CONTRA COSTA COMMUNITY COLLEGE

Contra Costa College
C-587 12kV Utility Upgrade

ADDENDUM #2 Date: June 20, 2011

drawing no.:
E212-A2

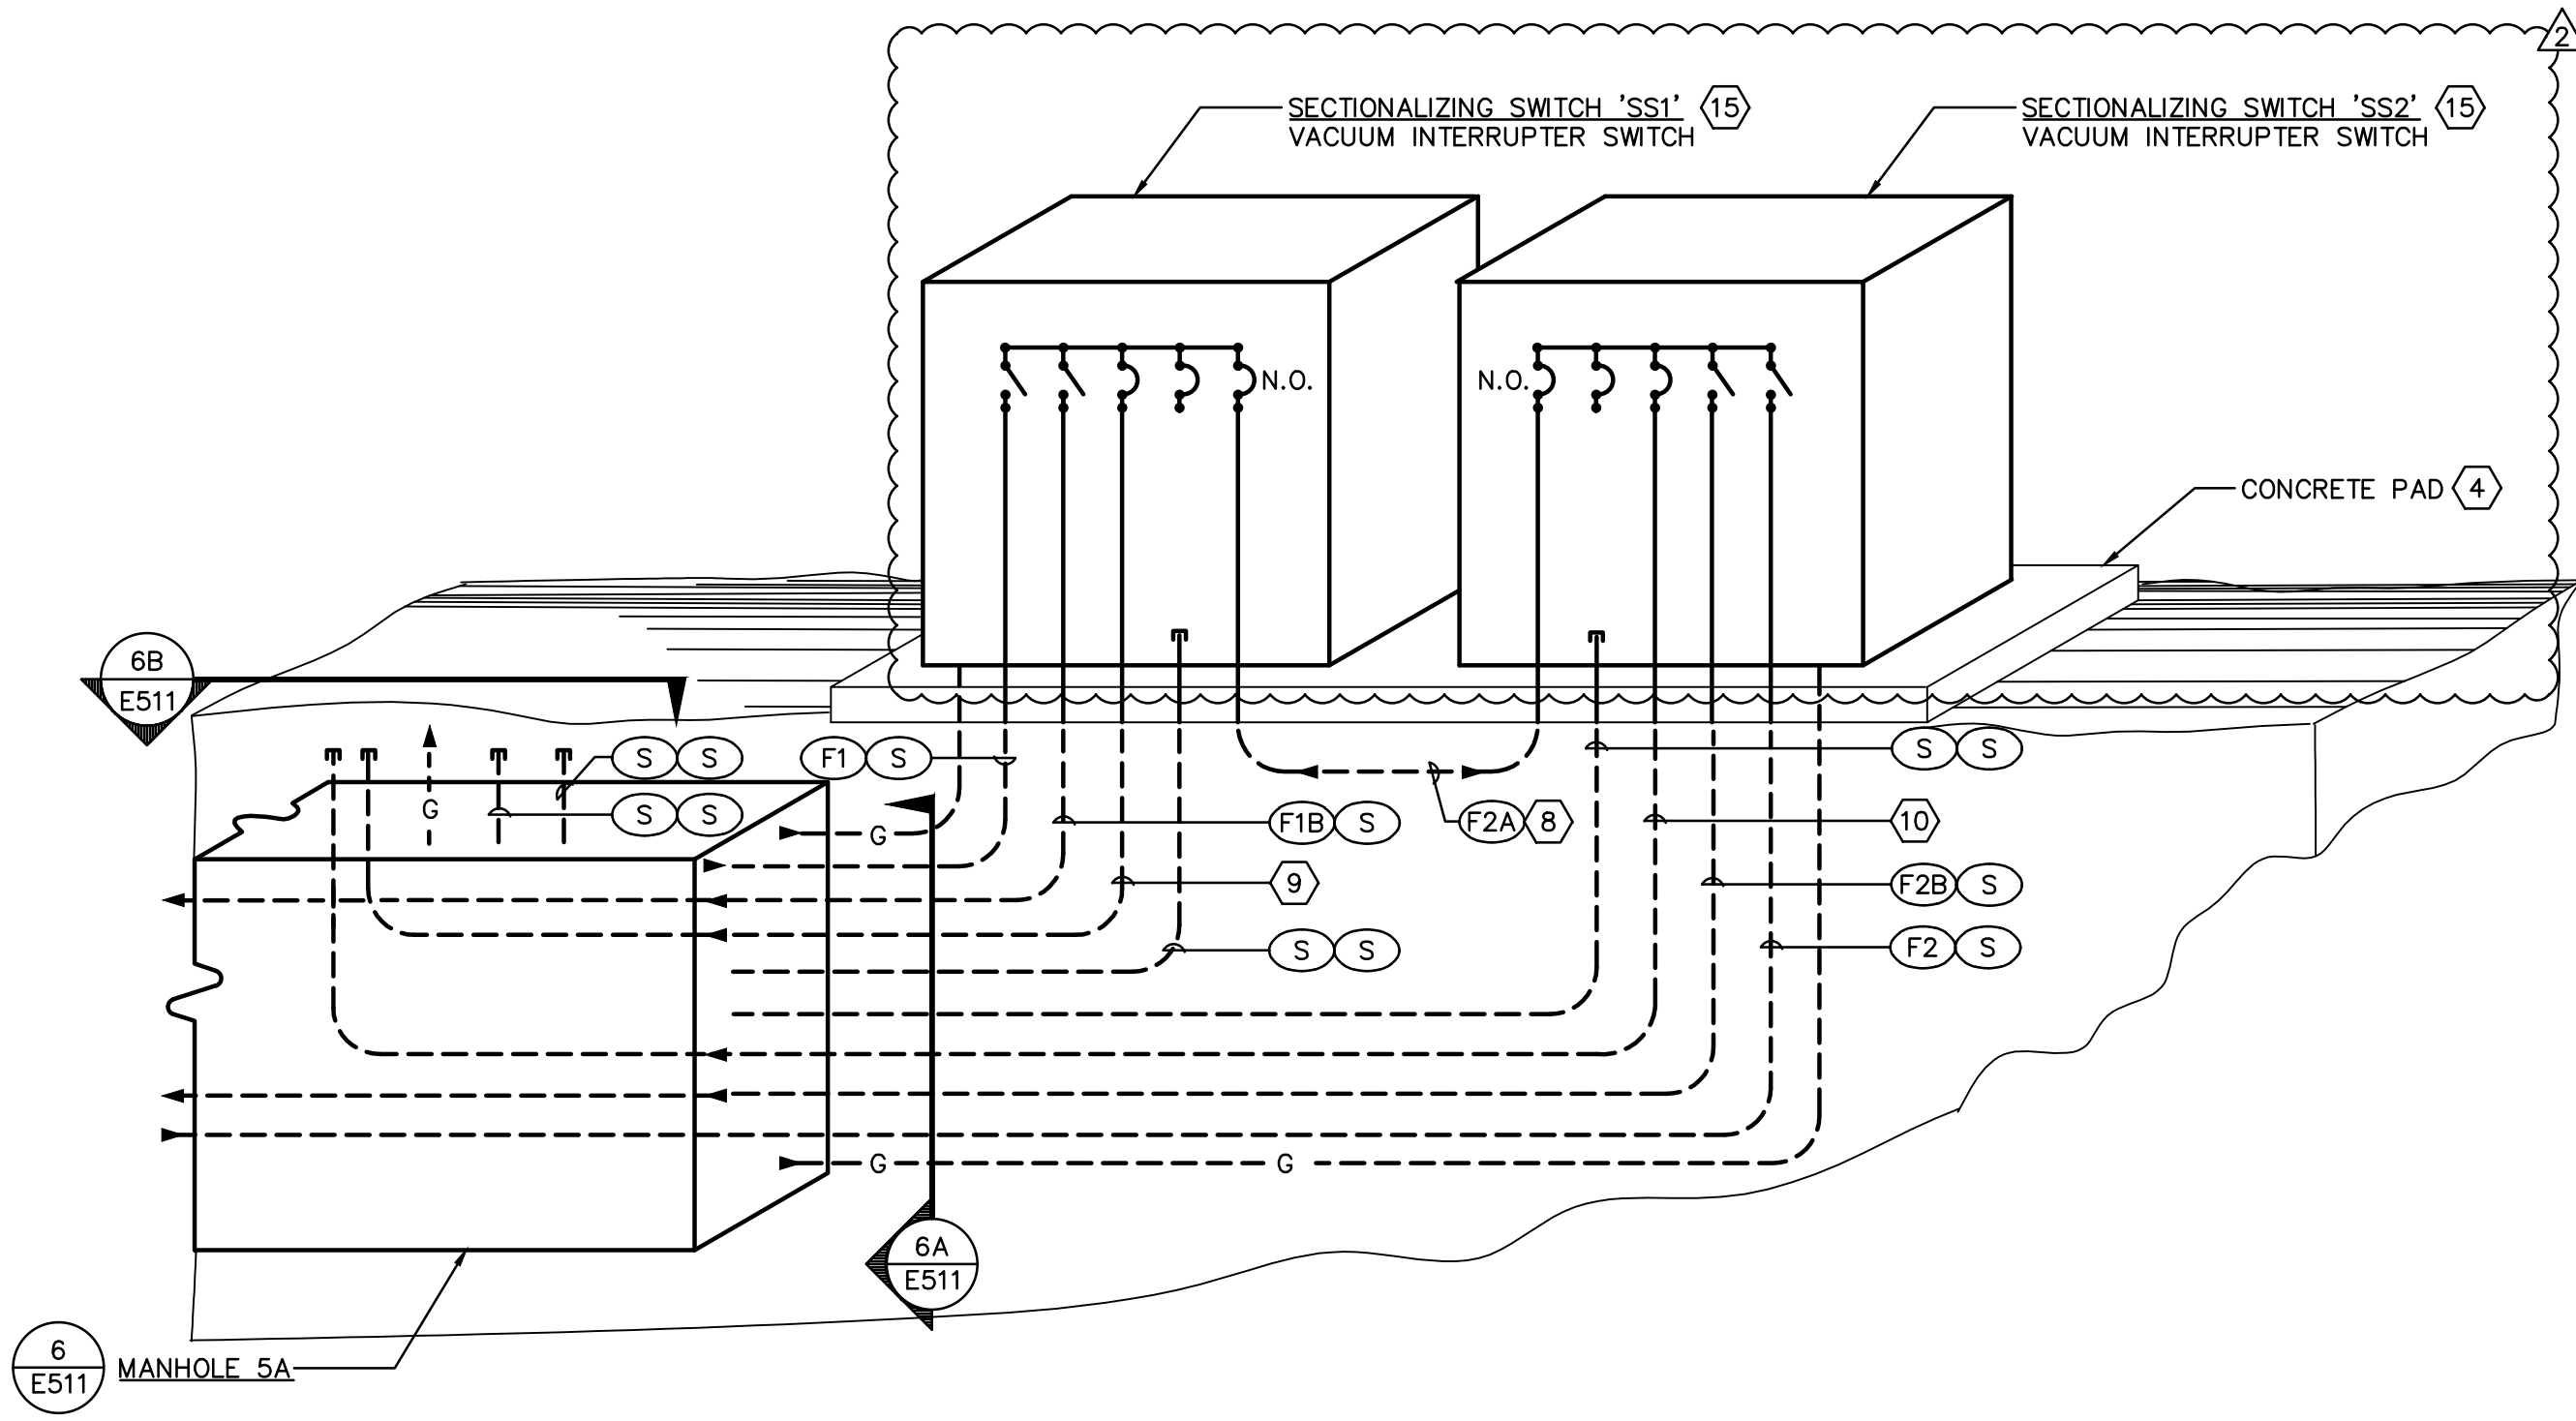
- Q2. Drawing E212 shows conduits F1, F2, and a spare as well as a note referencing detail 3 on drawing 511, detail 3 on page 511 shows that there are 4 spare conduits in this run. Is there to be one spare or four spare conduits in this ductbank?

- A2. Drawing E212 does not indicate quantities. Per Detail 3/E511, provide four spare conduits. The intent is to provide one spare conduit for F1, one spare conduit for F2, and two spare conduits for telecommunications.

drawing no.:
E312-A2

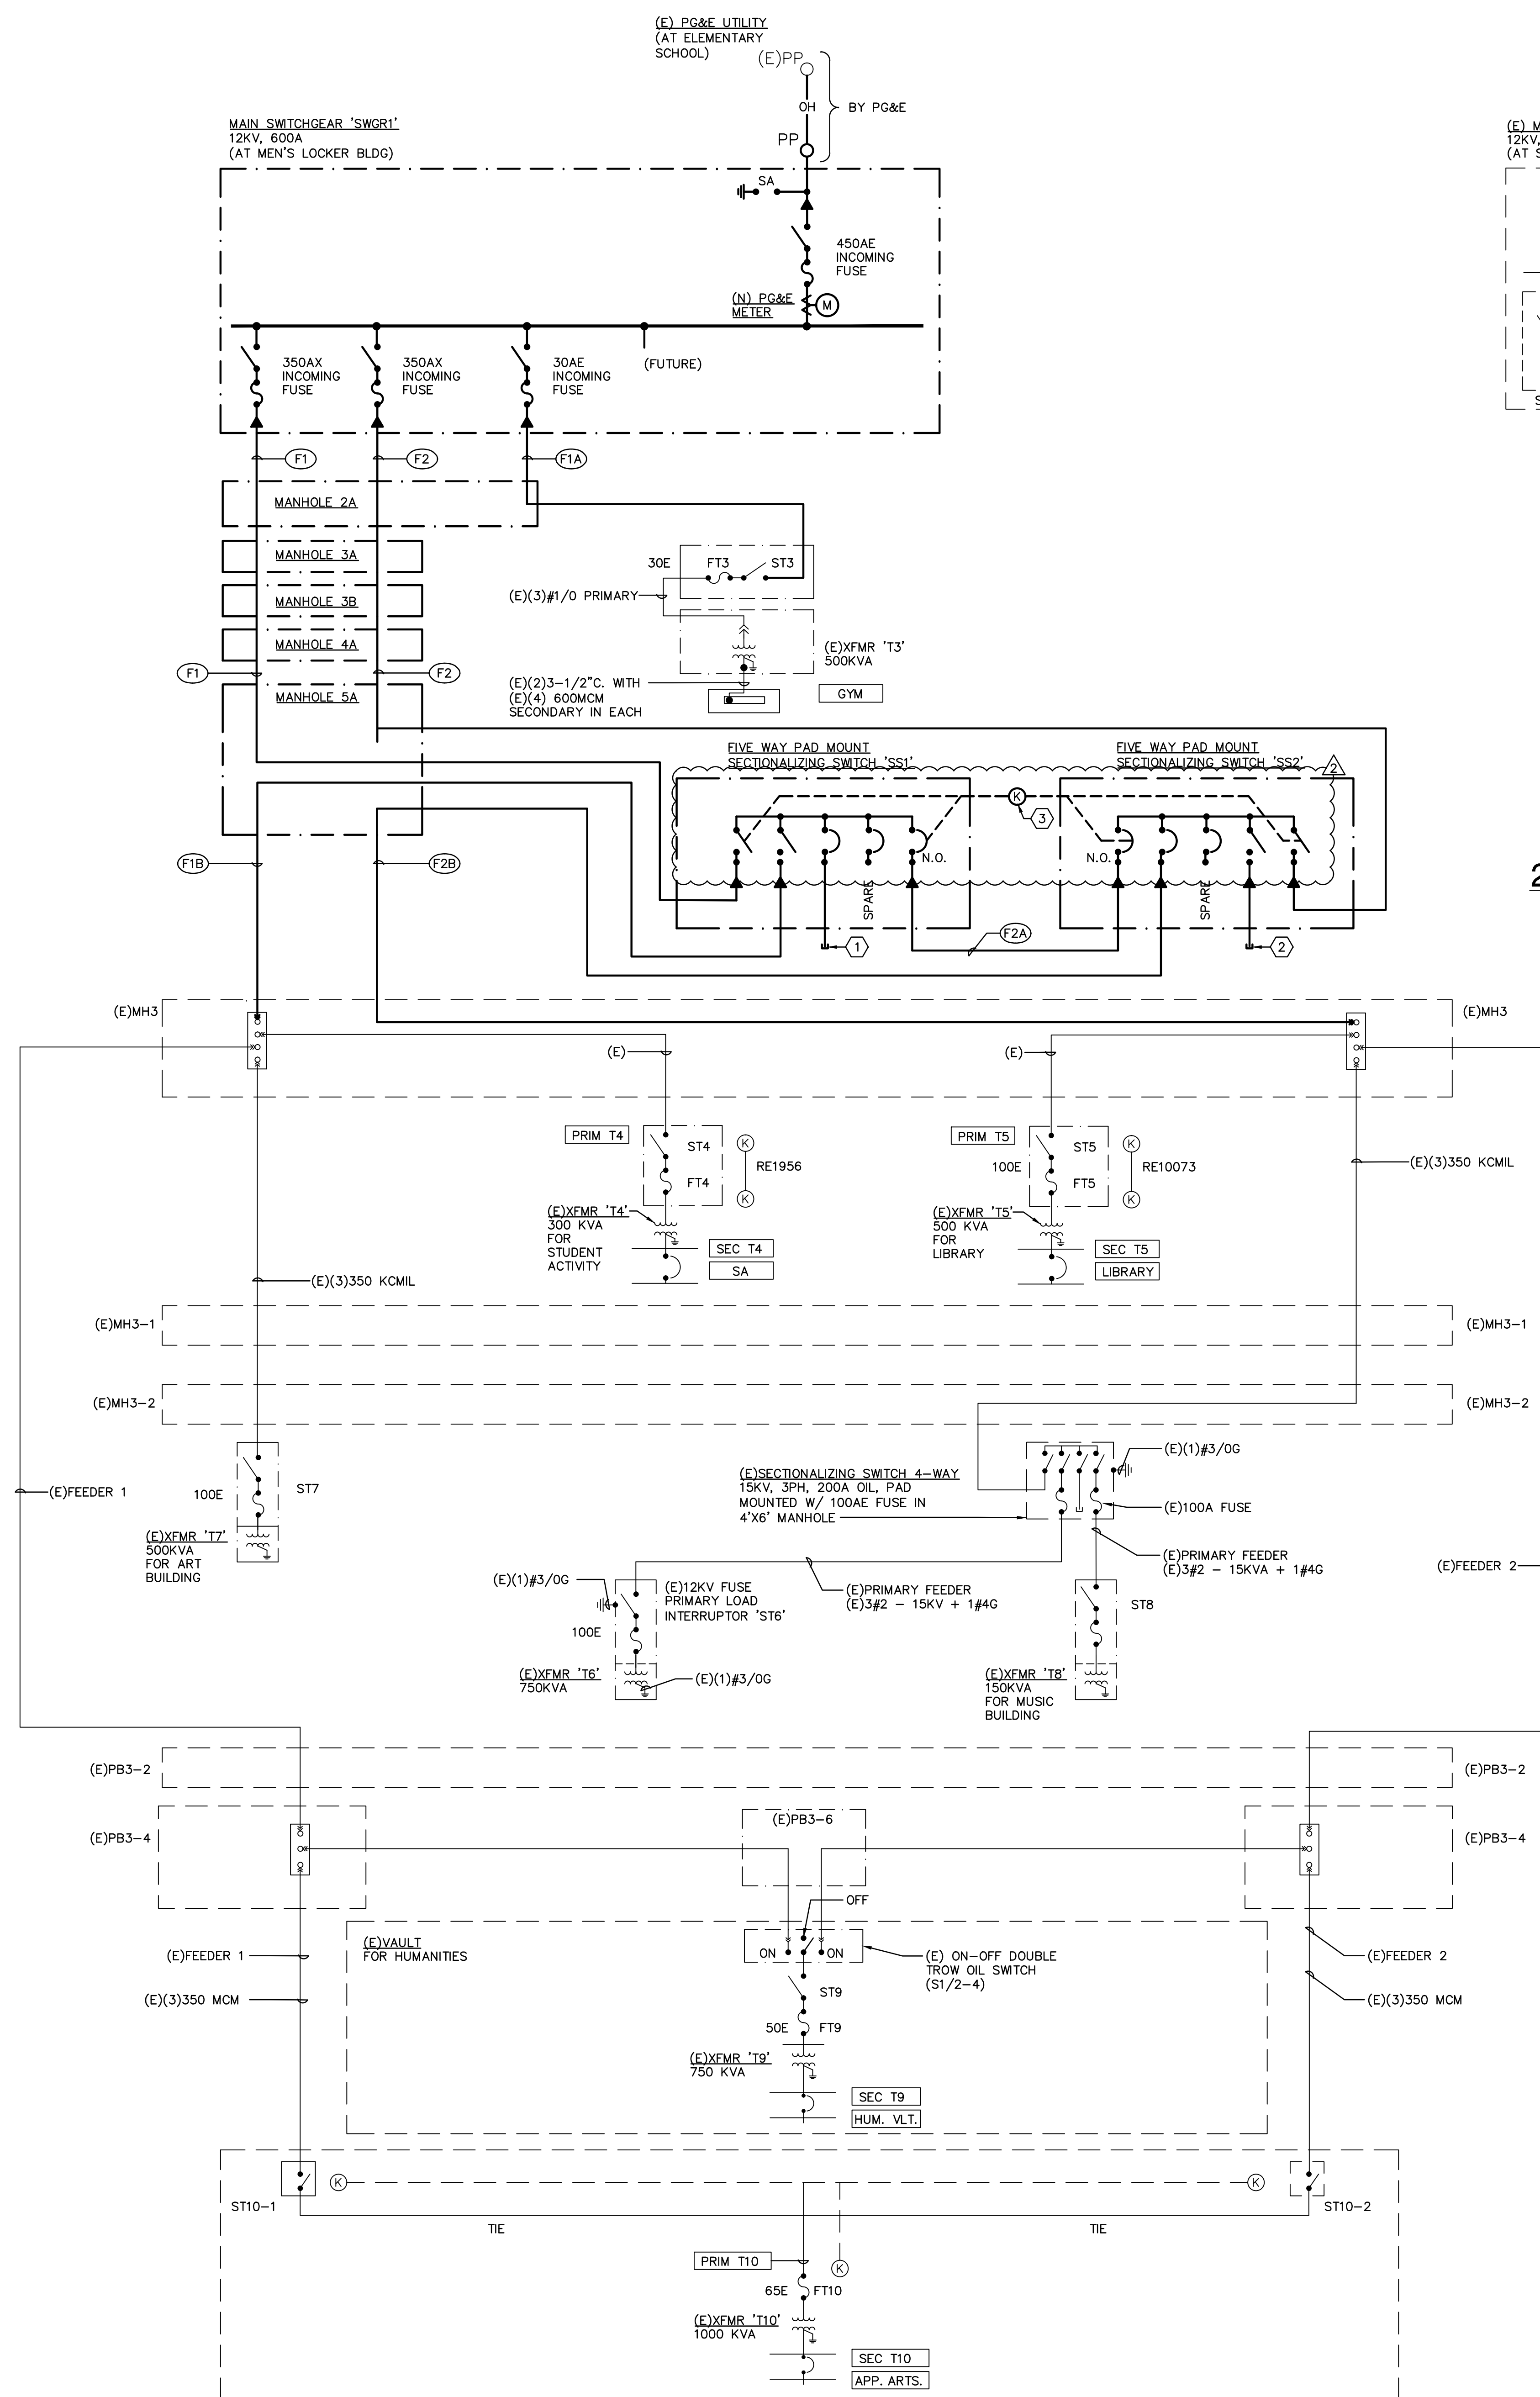
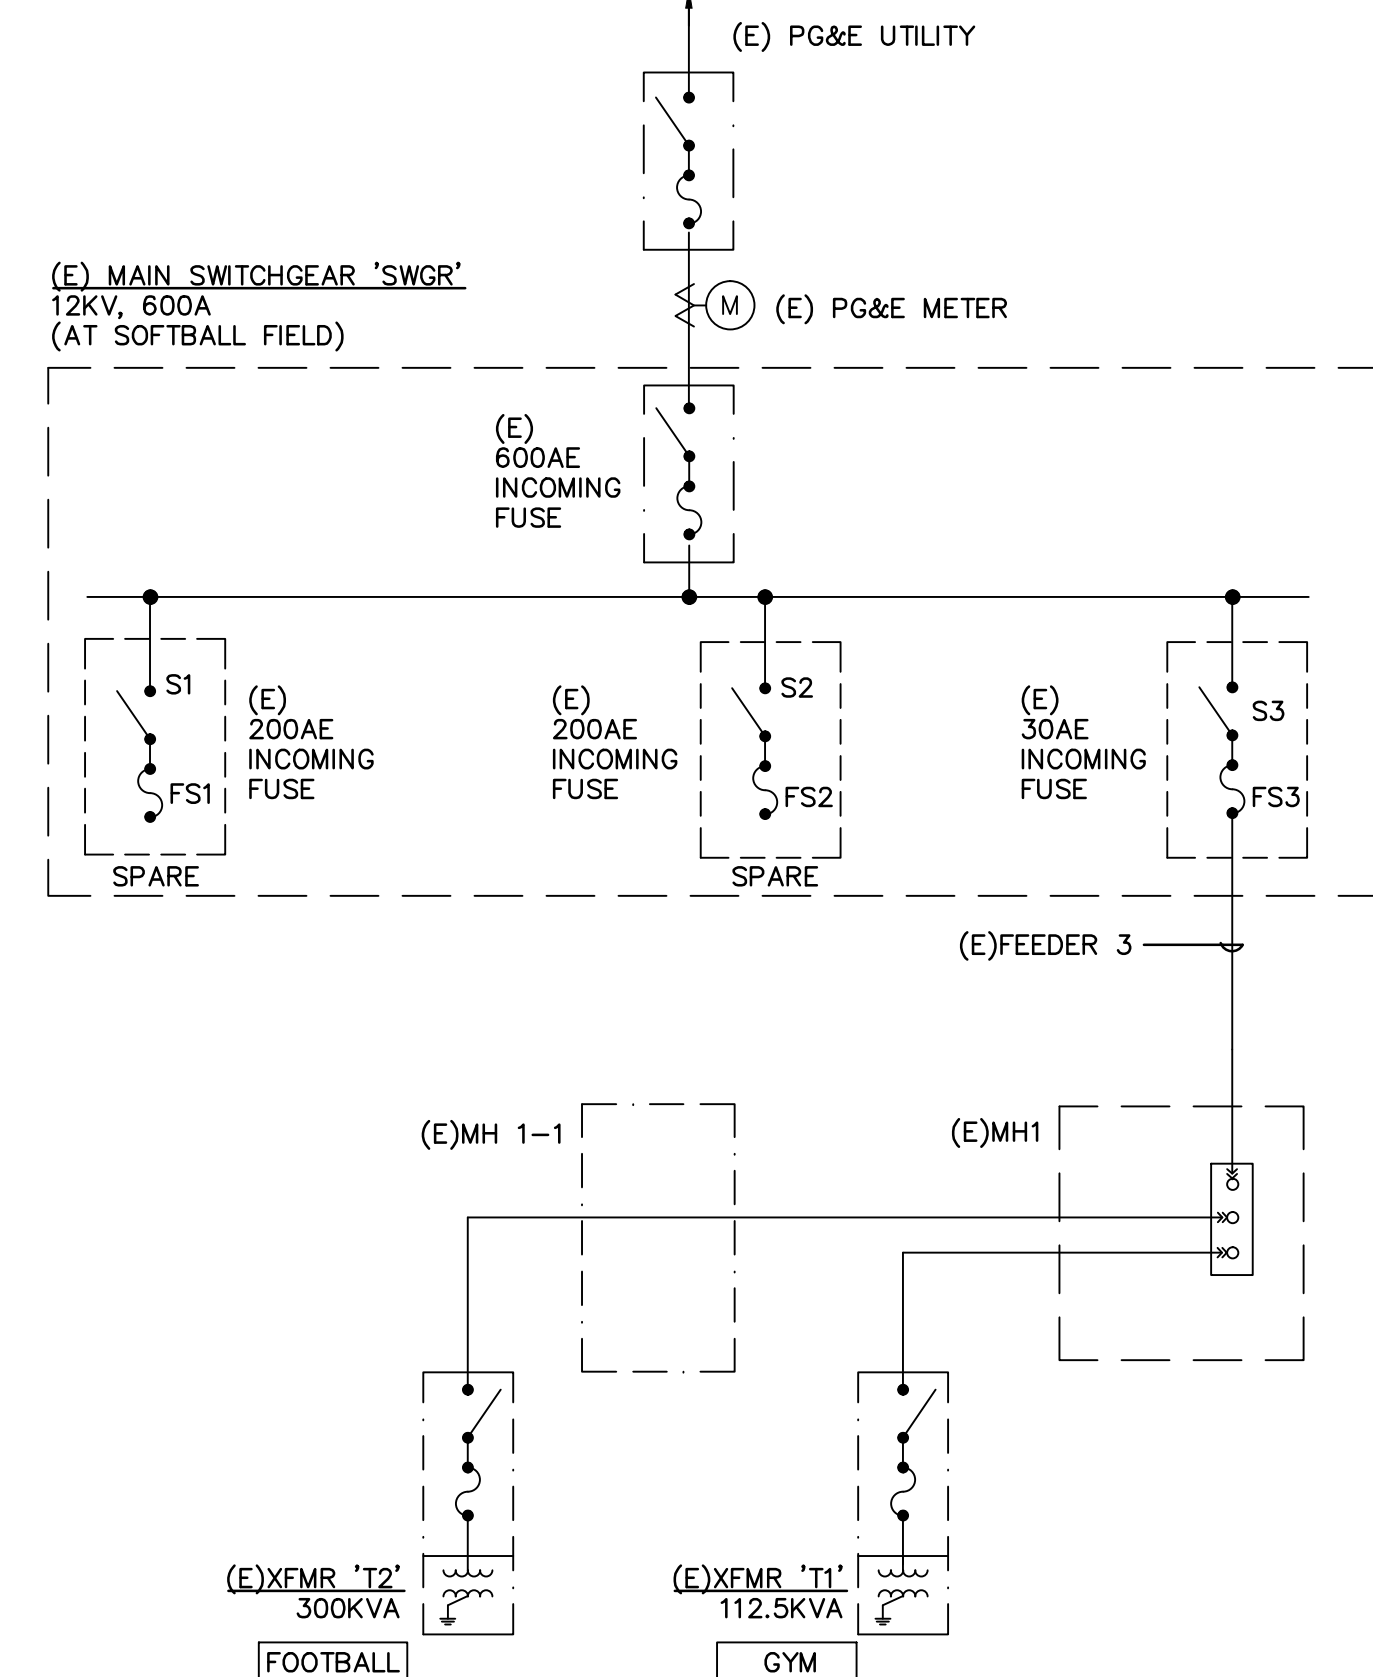
- 15. SEE SINGLE LINE DIAGRAM, SHEET E312-A2, FOR ADDITIONAL INFORMATION.
